**UNITED STATES OF AMERICA
BEFORE THE
FEDERAL ENERGY REGULATORY COMMISSION**

Docket No. ER11-2288

**AFFIDAVIT OF JAMES F. WILSON
IN SUPPORT OF PROTEST AND COMMENTS OF
THE JOINT CONSUMER ADVOCATES**

Figure 1: From the PJM Filing

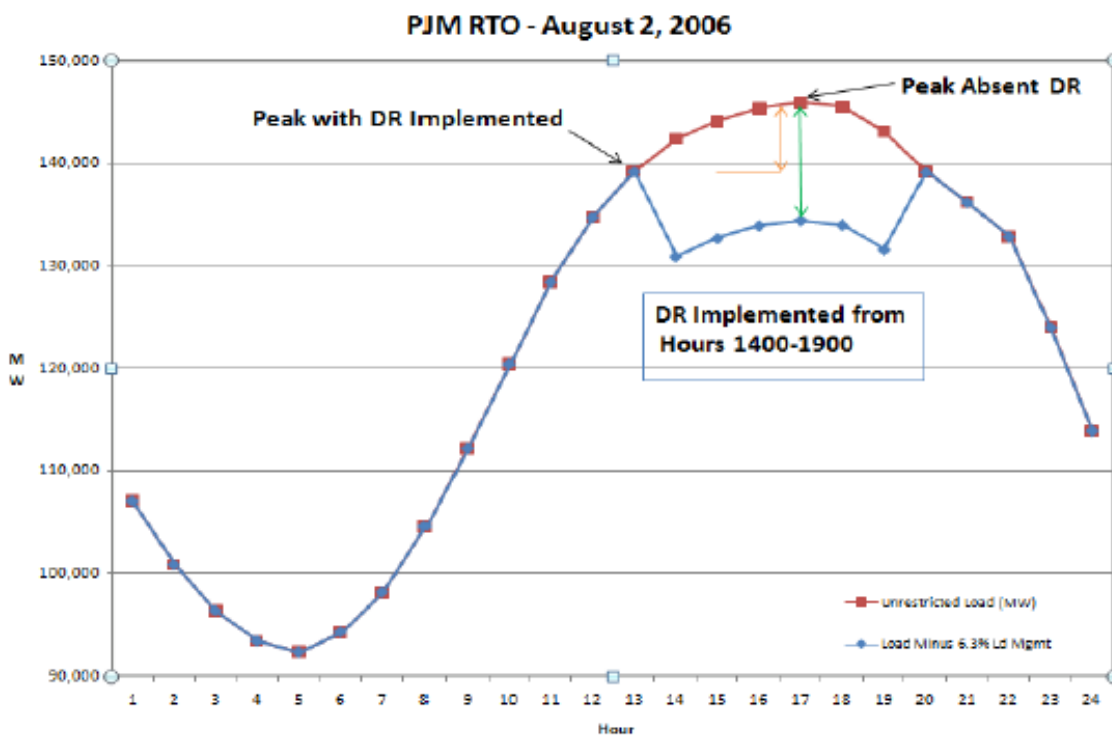
18. Both the Ten Call Analysis and the Duration Analysis rely upon the same critical assumption: that whenever PJM calls DR, it will call all available DR, and the DR will all perform during the exact same six hour interval. This assumption is illustrated in the figure that appears on page 14 of the filing and also on page 9 of the *May 2010 Analysis*, Exhibit 1 to the Falin Affidavit. This figure is included here as Figure 1.

19. Figure 1 shows that if all DR is implemented during the six-hour period from (hour ending) 1400 to 1900, and none operates outside that window, the daily peak does not decline by the quantity of DR, because the daily peak now occurs in an hour in which no DR was called (hour ending 1300). To put numbers around this, if the peak absent DR would have been 146,000 MW, and the quantity of DR was 12,000 MW, we would want the peak to decline by 12,000 MW to 134,000 MW assuming all DR is called. Instead, Figure 1 shows that if all DR is called for the six hours as shown, the daily peak is now in hour ending 1300 and is about 140,000 MW. As a result, the 12,000 MW of DR only reduced the daily peak by 6,000 MW (from 146,000 MW to 140,000 MW), and PJM did not obtain the full reliability impact of the DR. Notice that if the quantity of DR had been much smaller (say, 1,000 MW) the peak would have been reduced the full 1,000 MW, indicating that the DR Saturation problem is associated with larger quantities of DR.

**Figure 3: Load Management By Hour, RTO,
Days Selected For DR Saturation Duration Analysis (MW)**

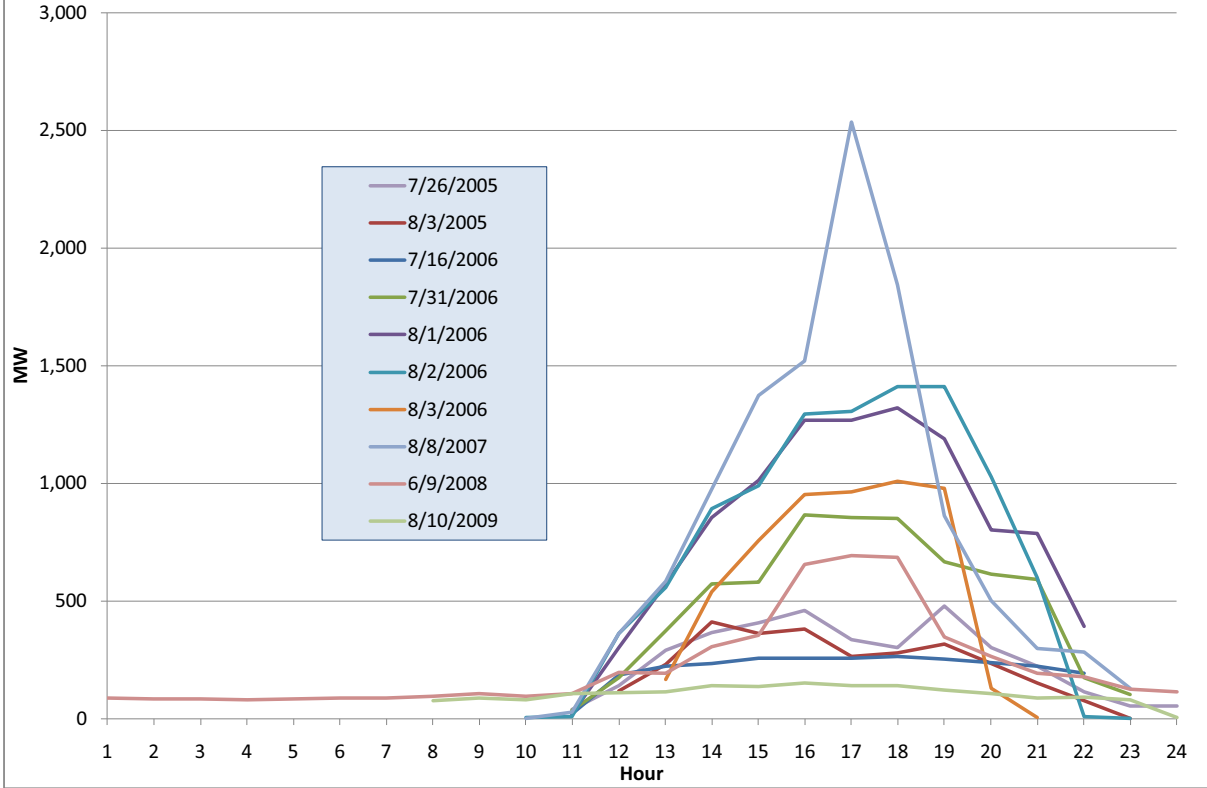
27. Over the ten days selected for the Duration Analysis, on average only 67% of the total MWh of load reduction was in the top six load hours, with 33% occurring outside the top six hours. The highest concentration was on two days in which 81% and 80% of the MWh were concentrated in the top six hours. For these same ten days, only 69% of the total MWh of load reduction was in the top six hours based on DR usage (rather than load) each day, and on only one day was over 81% concentrated into the top six hours. It is clear that, contrary to PJM’s

30. Figure 4 shows the hourly patterns of DR operation on the days selected for the Duration Analysis (the same data shown in Figure 3), but now expressed as a percent of the maximum hourly demand reduction on each day. The dark blue line is the average hourly DR as a percent of the daily maximum, representing the typical pattern of DR use. The red line is the average based on a slightly different method, averaging hours with the same rank rather than based on the actual hours.
